MUSIC VISION CORRECTIONS

TELCO IN A BOX CORRECTIONS

LETTERS

CORRECTED DIAGRAM for Music Vision article.

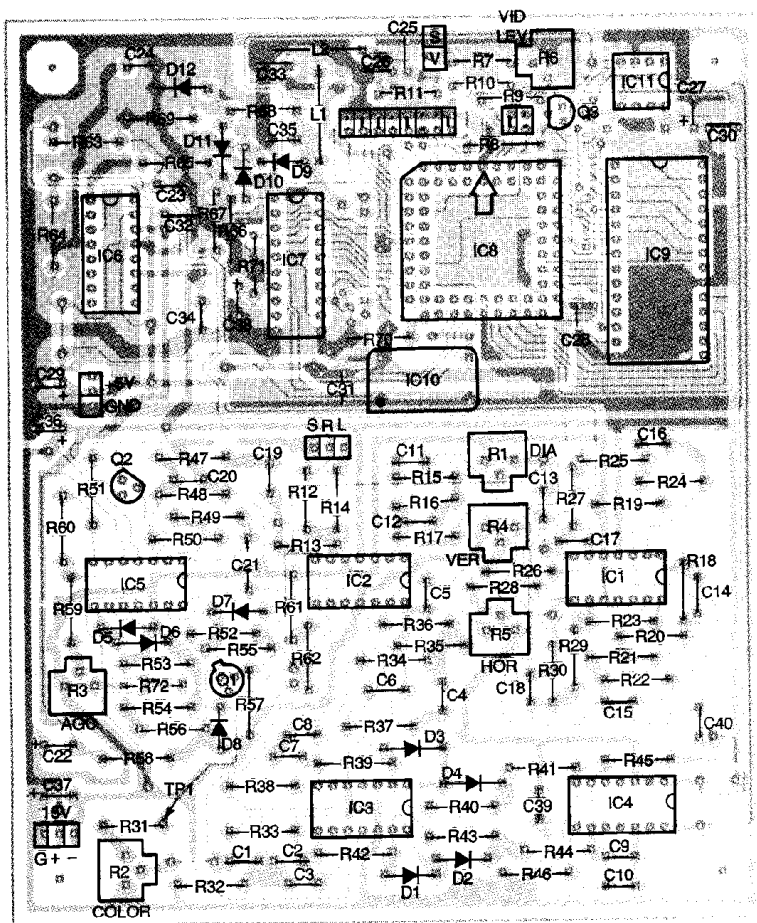
An error appeared in the parts placement diagram (Fig. 10) of the article, "Music Vision" (Electronics Now, November 1995). The label for resistor R59 was incorrectly placed; It appeared as an unlabeled jumper located below R60. In addition, the solder-side of the PC board was reversed in the X-ray view, Fig. 10. The corrected version is shown below.—Editor
